September 2020

SECTION 4.55(1A) MODIFICATION OF SSD-8574, WAITARA PUBLIC SCHOOL AT 48-58 MYRA STREET, WAHROONGA

Figure 2 Proposed modification (relevant spaces outlined red and numbered)

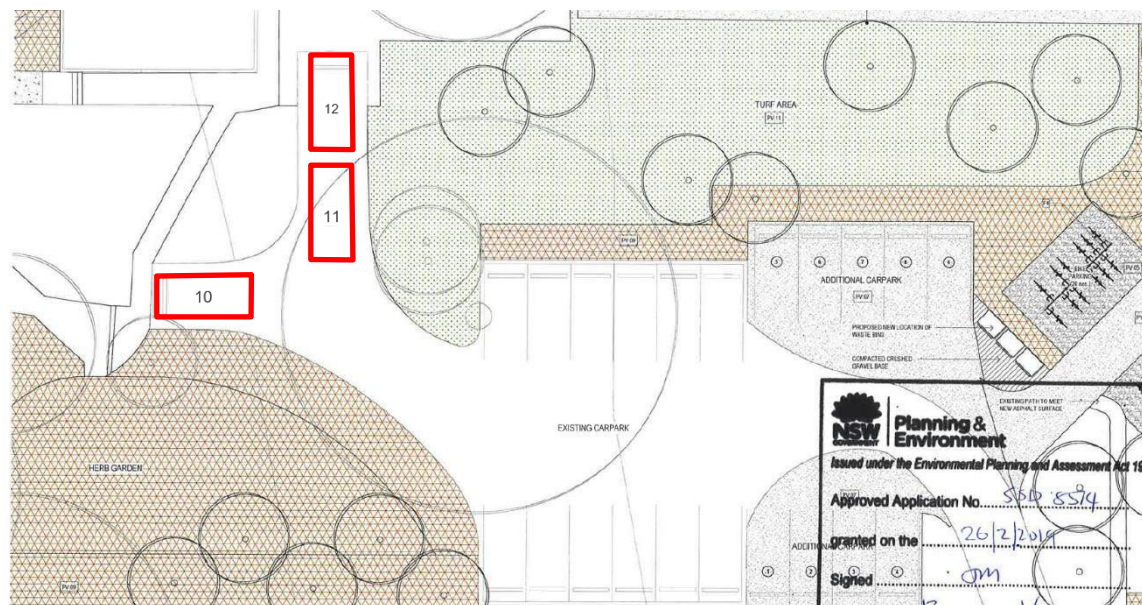
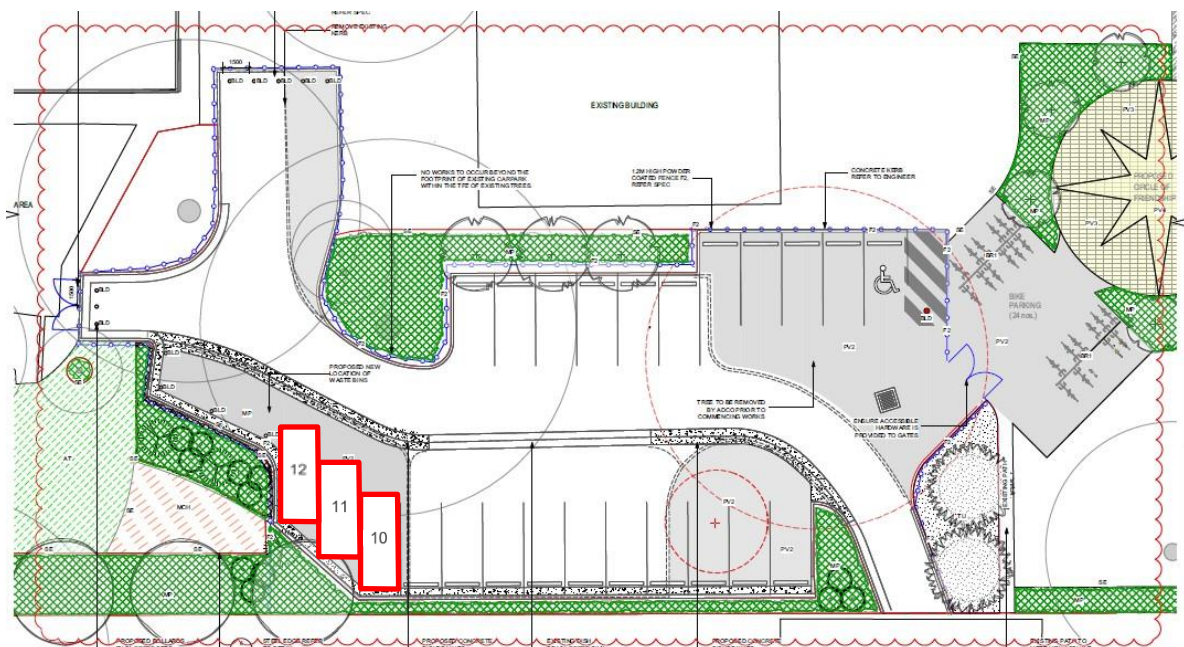
The approved car park design is proposed to be modified to relocate three parking spaces that were previously located within the turning area. Space has now been provided for these spaces within the main parking area, resulting in an improved outcome, refer Figure 2
(relevant parking spaces have been outlined red and numbered accordingly).

The modification results in an increase of 32m² of play space area however will not change the total number of car parking spaces provided as approved under the original consent. As such, there is a need to amend the relevant plans referenced in condition A2 as well as condition D10 which refers to the parking spaces.

The Design Verification Statement annexed to this letter at Appendix C confirms that the revised parking layout complies with AS2890.
